Docket Number:	00-AFC-01C
Project Title:	Contra Costa Power Plant Project Compliance
TN #:	204675
Document Title:	Petition for Insignificant Project Change to Plant Facility
Description:	Additional Decking on the East Side of the Steam Turbine Deck
Filer:	Patty Paul
Organization:	Pacific Gas & Electric Company
Submitter Role:	Applicant Representative
Submission Date:	5/21/2015 8:36:39 AM
Docketed Date:	5/21/2015

Subject: PETITION FOR INSIGNIFICANT PROJECT CHANGE TO PLANT FACILITY
(Additional Decking on the East Side of the Steam Turbine Deck)

**PETITION FOR INSIGNIFICANT PROJECT CHANGE
AT
GATEWAY GENERATING STATION (GGS)**

1. Installation of Additional Decking on East Side of Steam Turbine Deck:

SHEET TITLE: STEAM TURBINE DECK
MODIFICATIONS
CONCEPTUAL DESIGN - NOT FOR CONSTRUCTION
OWNER: PACIFIC GAS & ELECTRIC COMPANY
GATEWAY GENERATING STATION
ANTIOCH, CA. 94509

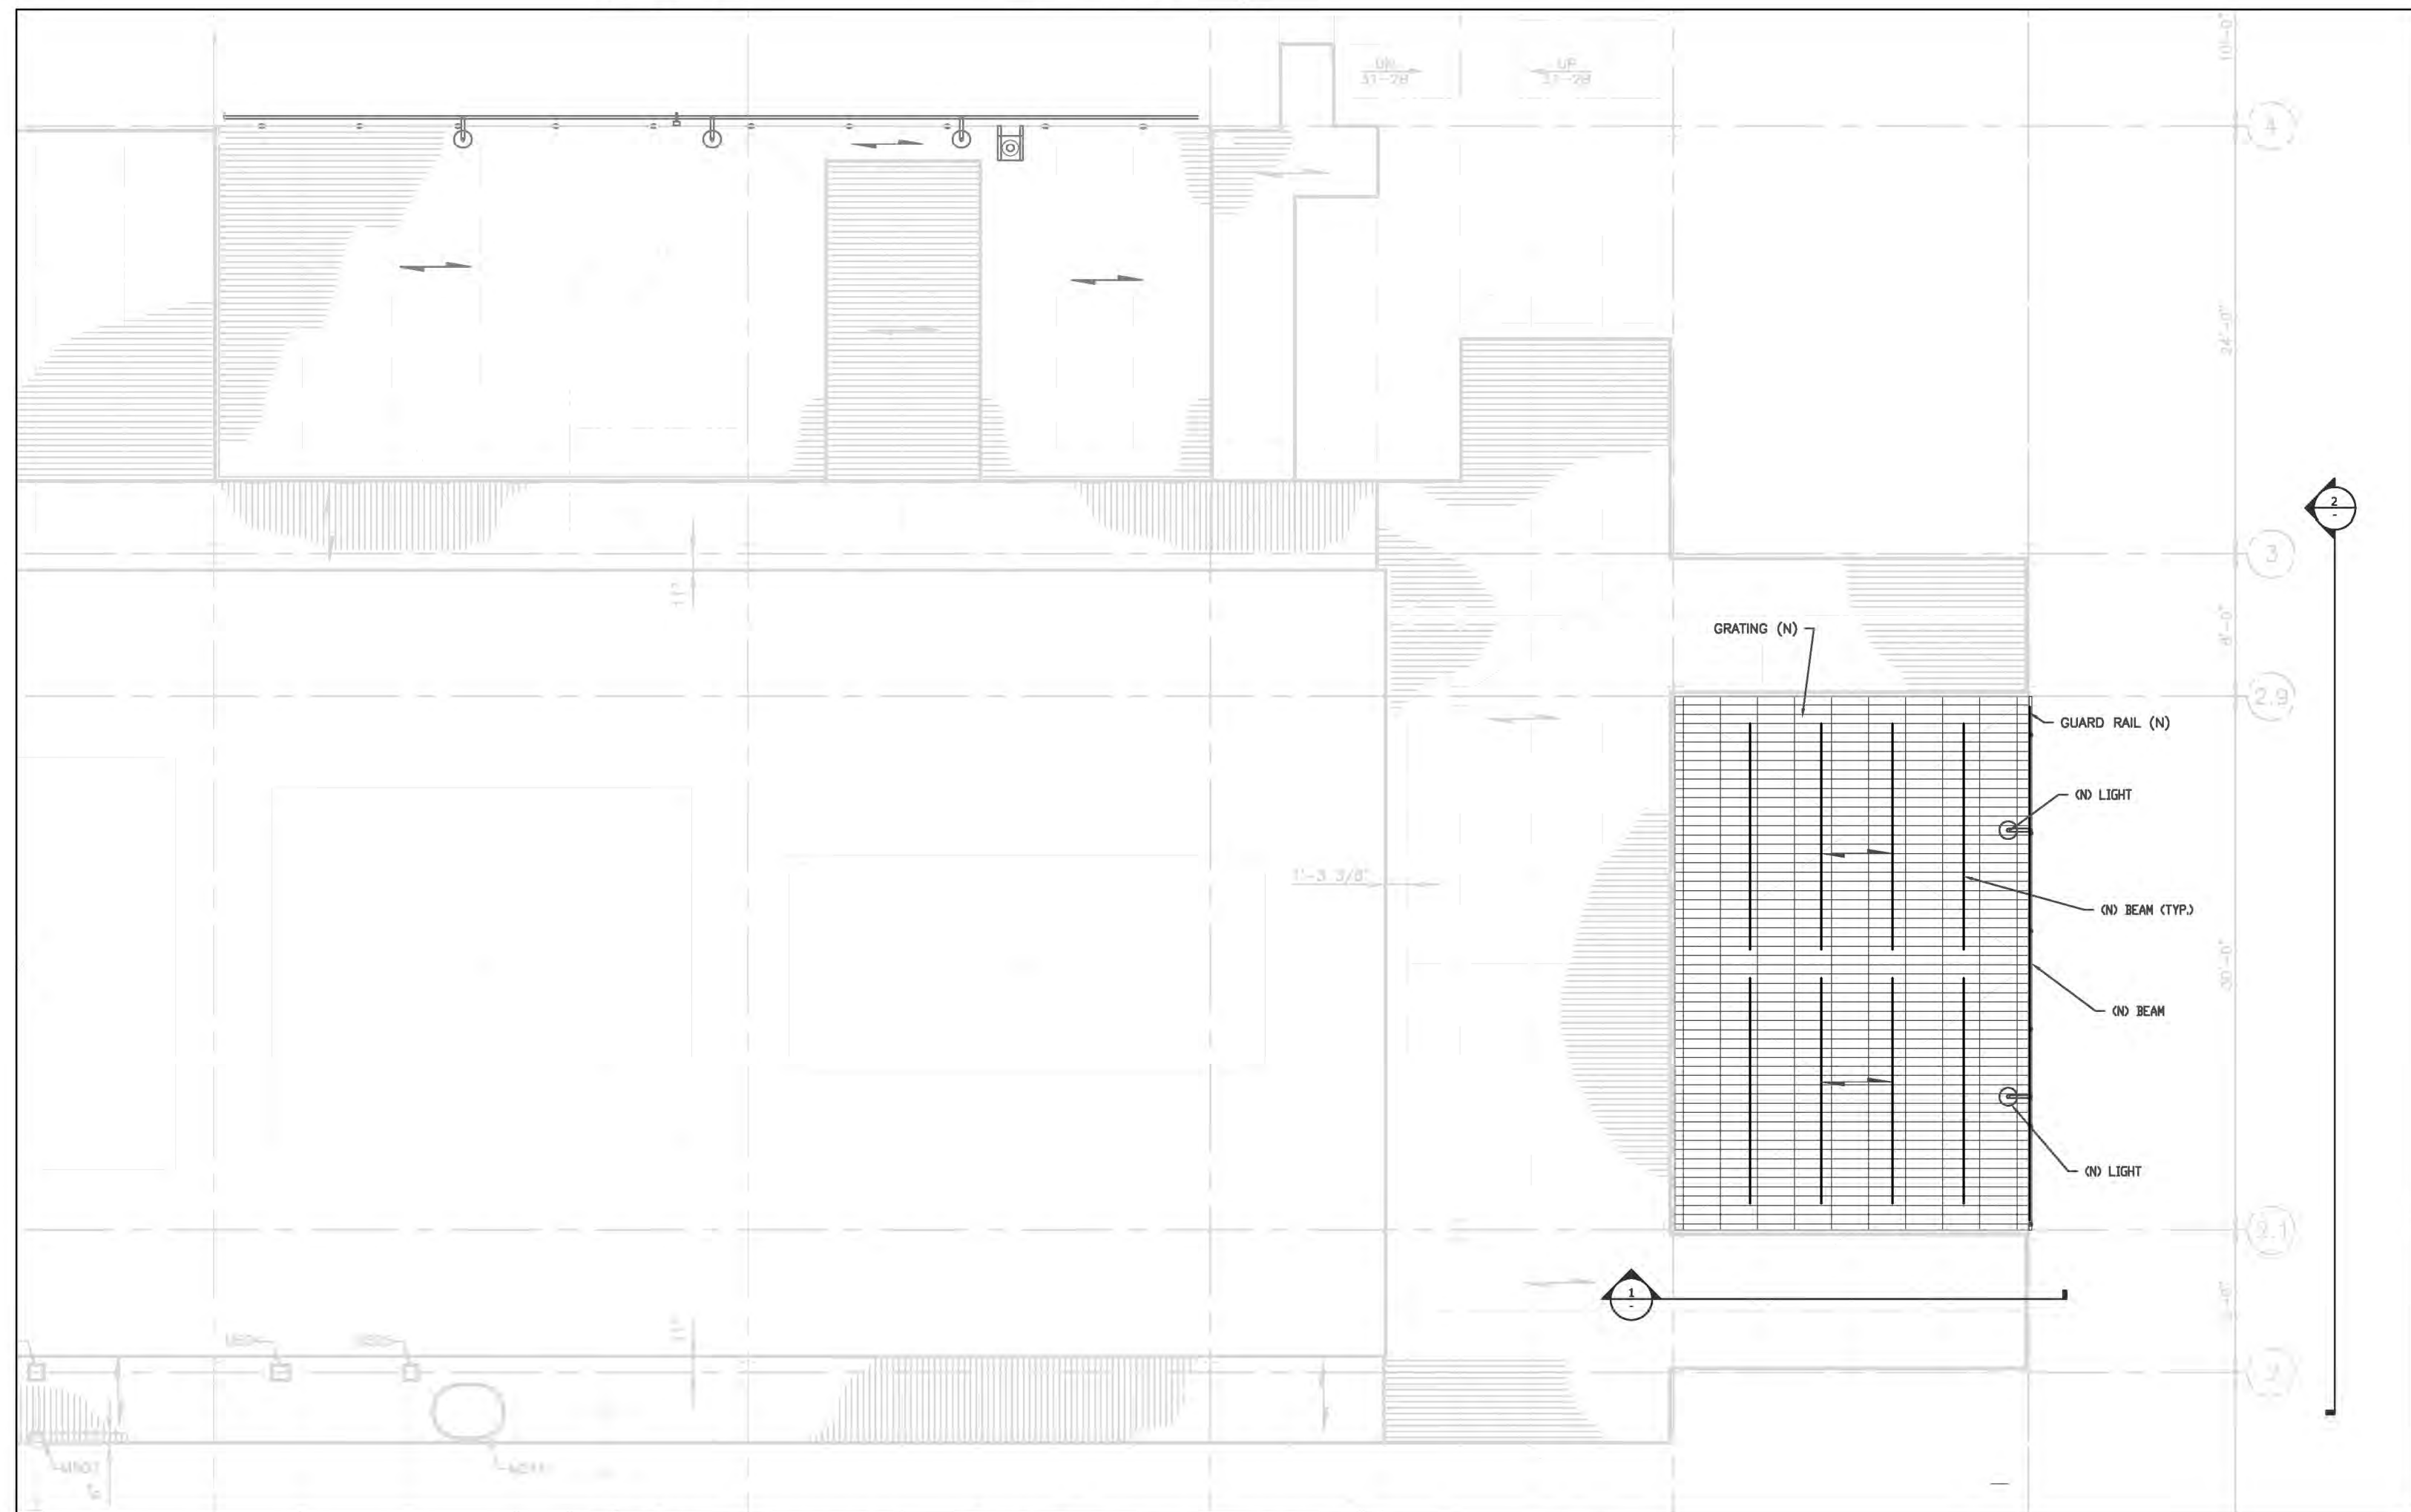
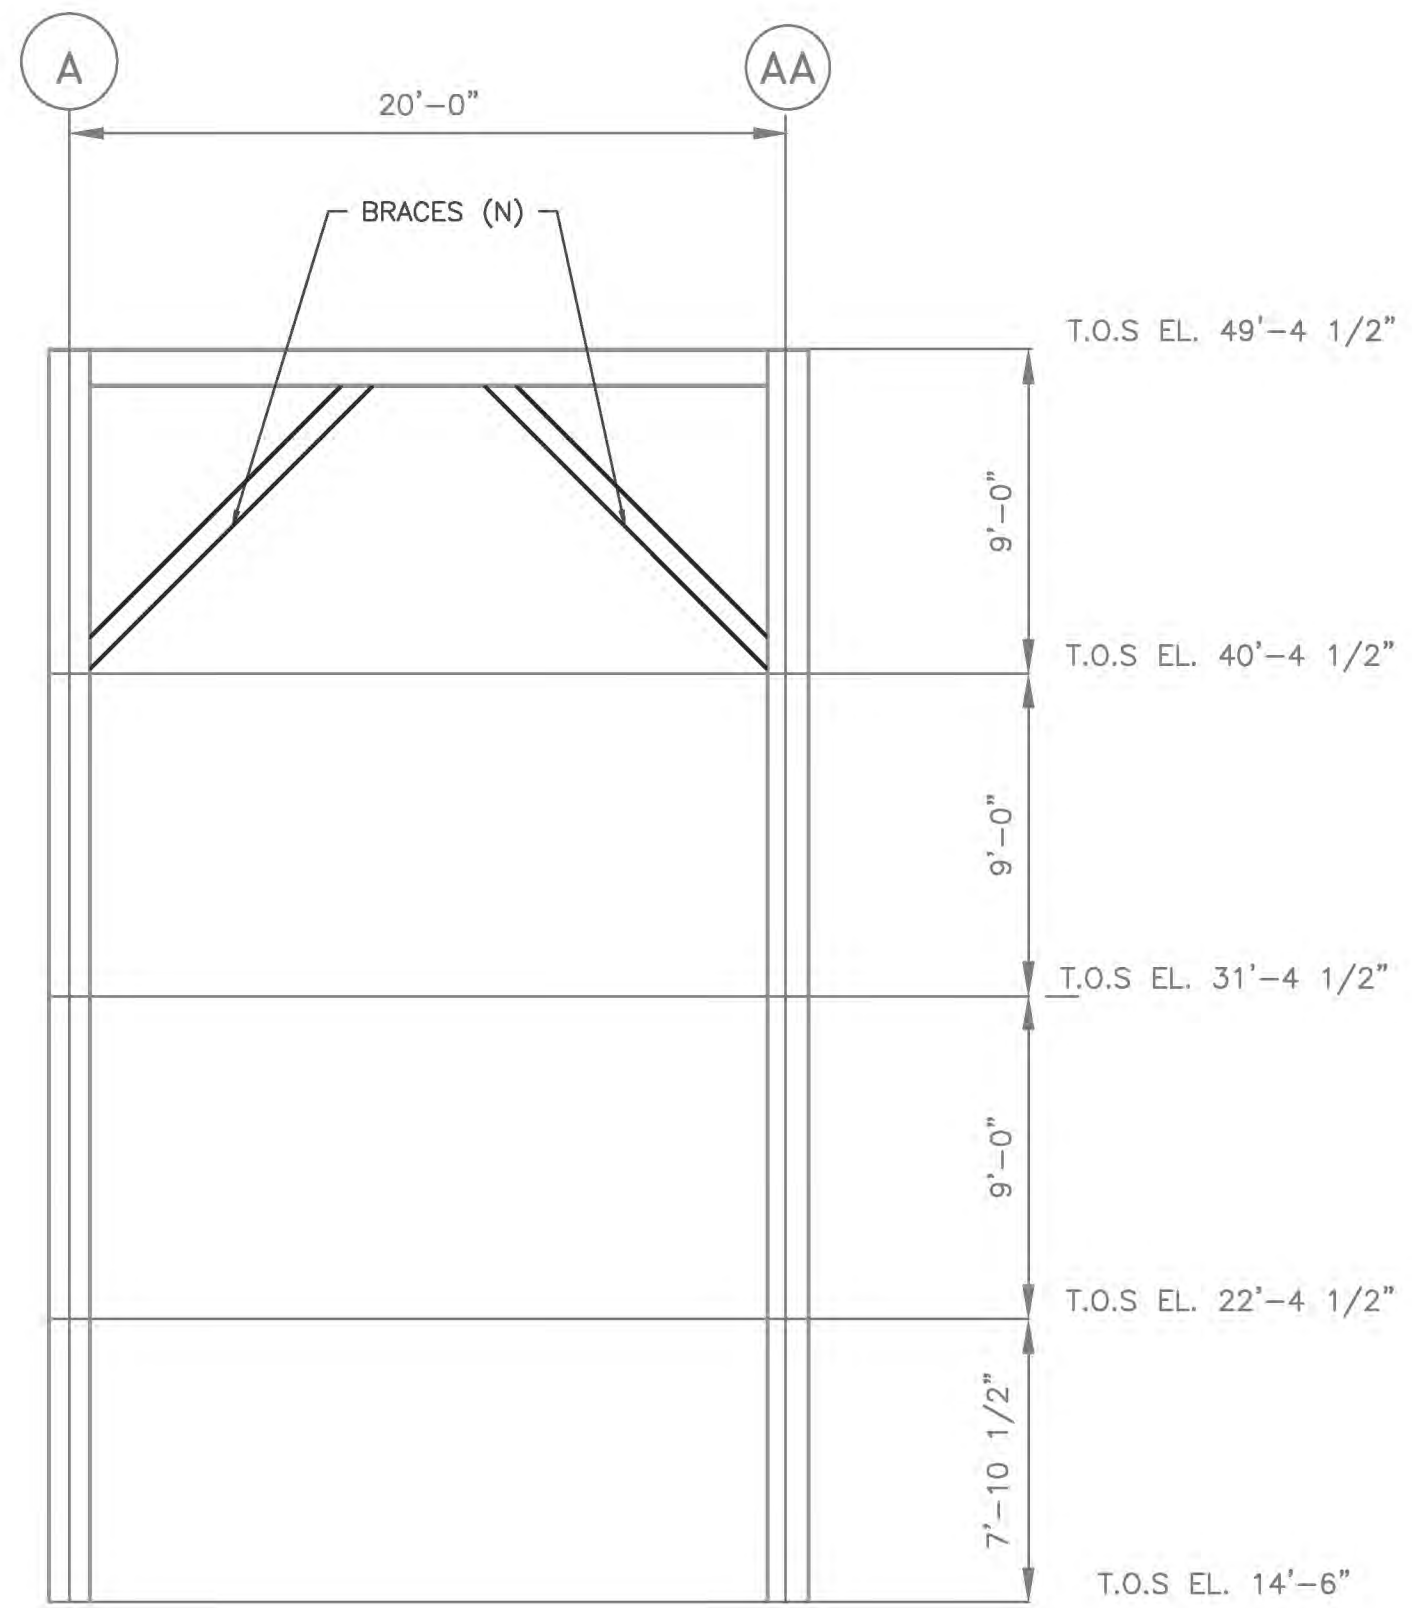
The current Gateway Generating Station (GGS) steam turbine deck configuration has one open area on its east side which was not originally fitted with grating-type decking during plant construction -- see proposed grating addition area outlined in red in left side lower half of Figure 1 (see attached drawing).

- a. Description of Modification: PG&E proposes to: (See the “Conceptual Demo Plan” portion of the left side upper half of Figure 1 for reference for Items 1 through 3): (1.) Remove the lighting and associated electrical power supply conduit runs currently installed along the west perimeter of the subject open Steam Turbine (ST) Deck area; (2) Remove the guard rails installed along the north, west and south perimeters of the subject open ST Deck area; (3) Perform the X-brace and east side structural beam modifications shown in the left side upper half of Figure 1; (4) Install additional structural brace beams – see the “Elevation 1” section of Figure 1 (south side of subject section of ST Deck looking north) and in the “Elevation 2” section of Figure 1 (east side of subject section of ST Deck looking west) – attached to the structural column beams and underlying horizontal decking support beams as shown in Elevations 1 and 2 of Figure 1, to provide support under the area to which grating-type decking is being added; (5) Install grating-type decking in the area outlined in red as depicted in the “Conceptual Const. Plan” portion of the left side lower half of Figure 1; (6) Re-install the lighting, associated electrical power supply conduit runs, and guard rail along the east perimeter of the subject open area. This proposed project will not require excavation or any ground disturbing activity. The relocation of lighting and electrical power supply conduit runs will be done above ground at the elevation of the existing turbine deck. This project is planned to be started in July 2015.
